Access Compliance Report

Public Rights-of-Way

Intersection ID: 47662	Main Street: CANDLESTICK_CT	Cross Street: COMISKEY_LN	Location: SW
ADA ID: 36343E8EC30D	Ramp Type: Perp	Initial Pass/Fail: Fail	Overall Compliance: No
Codes/Mitigation Info/Possible Solution		Field Measurements/Component Compliance

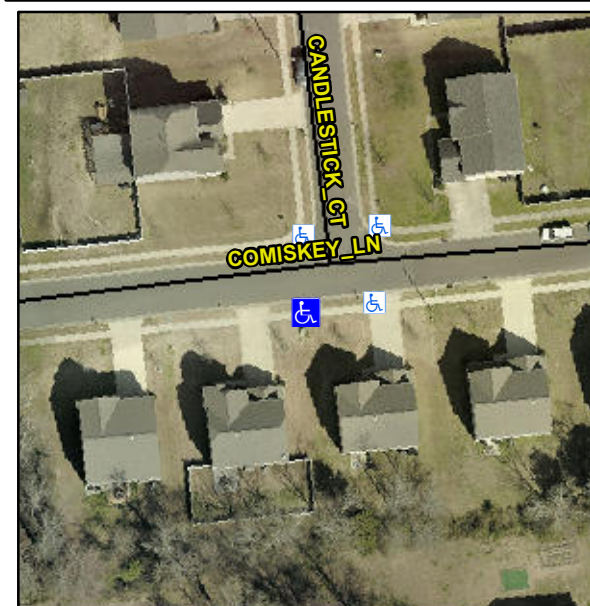
Not Found, R304.2.2

Compliance	Description	Data	Compliance	Description	Data
N/A	Ramp Length (in)	47.5	No	Ramp Slope (%)	8.9
Yes	Ramp Width (in)	48.0	Yes	Ramp XSlope (%)	2.8
N/A	Flare Type LT	N/A	N/A	Flare Type RT	N/A
N/A	Flare Slope LT (%)	N/A	N/A	Flare Slope RT (%)	N/A
N/A	Flare Traversable LT?	N/A	N/A	Flare Traversable RT?	N/A
N/A	Landing Length (in)	N/A	N/A	DWS Provided?	N/A
N/A	Landing Width (in)	N/A	N/A	DWS Contrast?	N/A
N/A	Landing Slope (%)	N/A	N/A	DWS Length (in)	N/A
N/A	Landing X Slope (%)	N/A	N/A	DWS Full Width?	N/A
N/A	Landing Curb? (Y/N)	N/A	N/A	DWS Offset (in)	N/A
N/A	Shared Landing?	N/A			
N/A	Gutter Ponding?	N/A	N/A	Gutter Slope (%)	N/A
N/A	Gutter Lip Ht (in)	N/A	N/A	Gutter X Slope (%)	N/A
N/A	Painted X Walk1?	No	N/A	Painted X Walk2?	N/A
	X Walk 1 Direction	To N		X Walk 2 Direction	N/A
N/A	X Walk 1 Width (in)	N/A	N/A	X Walk 2 Width (in)	N/A
	X Walk 1 Slope (%)	2.8		X Walk 2 Slope (%)	N/A
	X Walk 1 X Slope (%)	2.8		X Walk 2 X Slope (%)	N/A

Remove & Replace Entire Ramp.
